The Commission has issued the enclosed Amendment No. 42 to Facility Operating License No. DPR-64 for the Indian Point Nuclear Generating Unit No. 3. This amendment consist of changes to the Technical Specifications in response to your application transmitted by letter dated January 6, 1982.

INDIAN POINT NUCLEAR GENERATING UNIT NO. 3

AMENDMENT TO FACILITY OPERATING LICENSE

Amendment No. 42  
License No. DPR-64

FIGURE 6.2-1

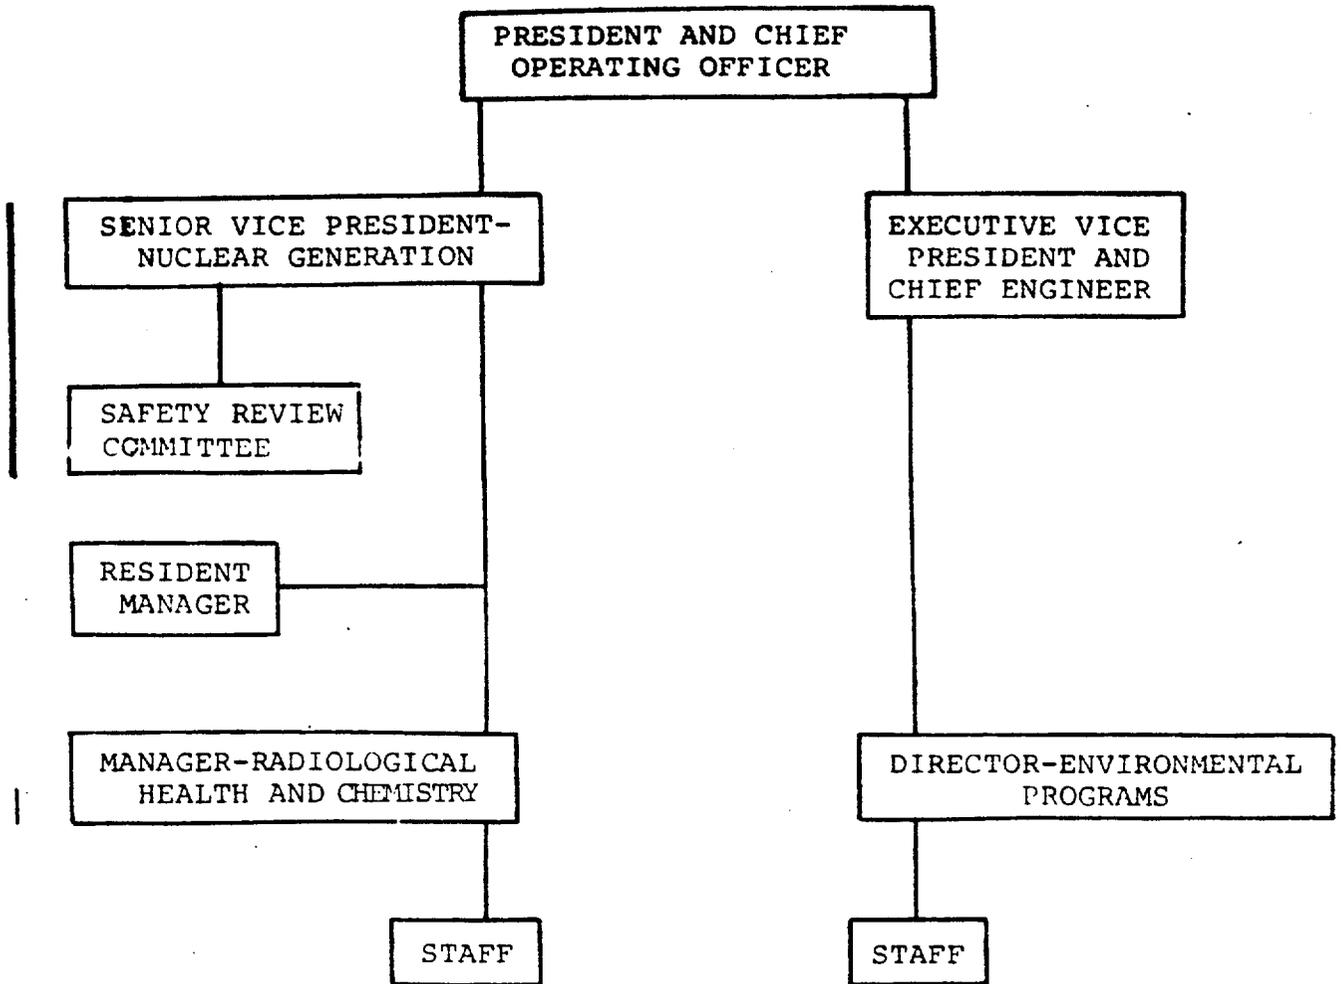
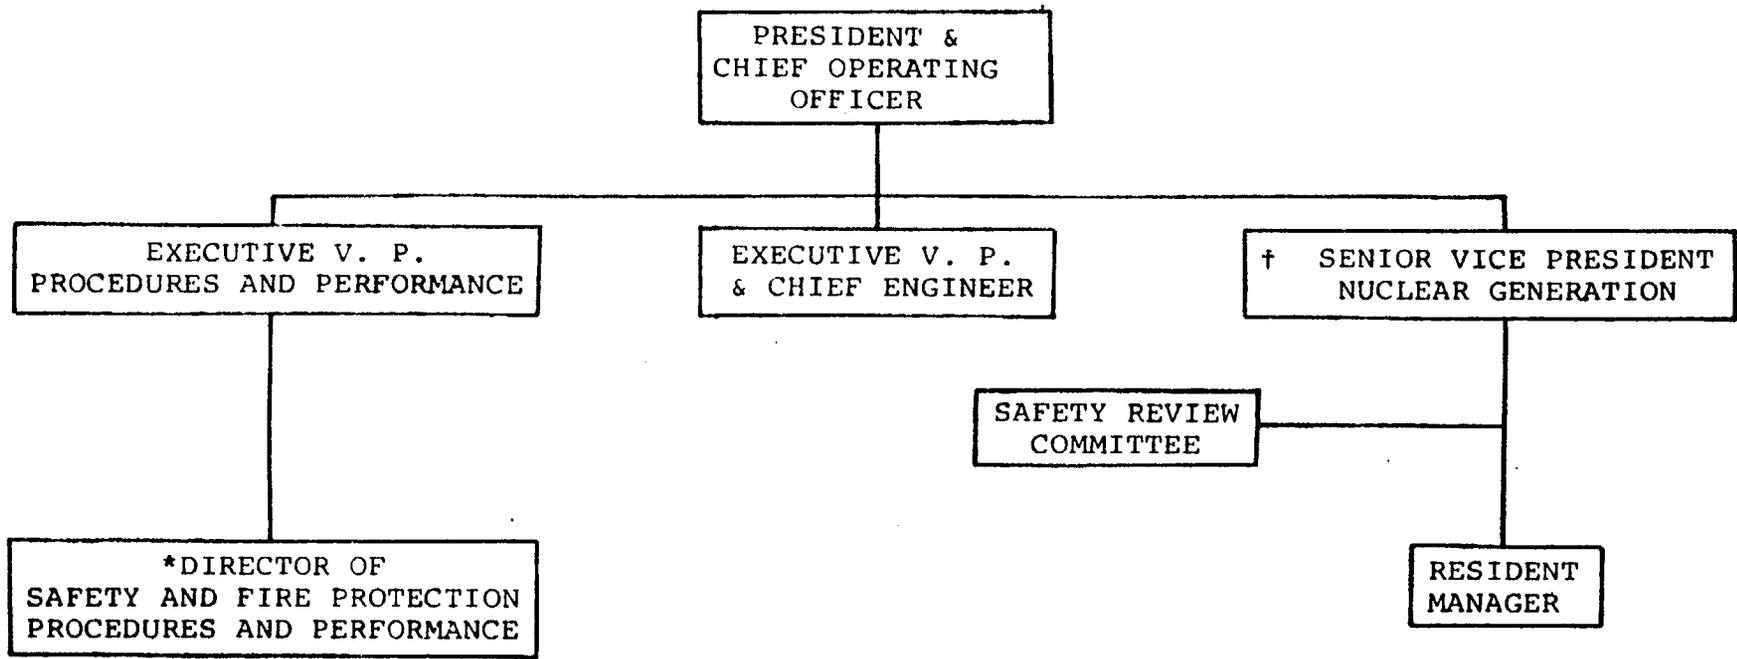
The amendment revises the provisions in the Technical Specifications to allow the reorganization of the Indian Point Unit No. 3 Safety Review Committee. In essence, personnel titles and reporting requirements have been changed in order to clarify and unify responsibilities. Using various tools, such as the Task Action Plan, Regulatory Guide 1.33 and ANSI 18.7/ANS 3.2 guidelines we reviewed the Indian Point Unit No. 3 management organization to assure that the proposed change does not diminish the level of safety with respect to organization and technical resources provided by the existing Technical Specifications.

The amendment revises the provisions in the Technical Specifications to allow the reorganization of the Indian Point Unit No. 3 Safety Review Committee.

†The Senior Vice President Nuclear Generation is responsible for administering the fire protection program.

\*The Director of Safety and Fire Protection is the off-site management position responsible for assessing the effectiveness of the fire protection programs by conducting reviews and audits.
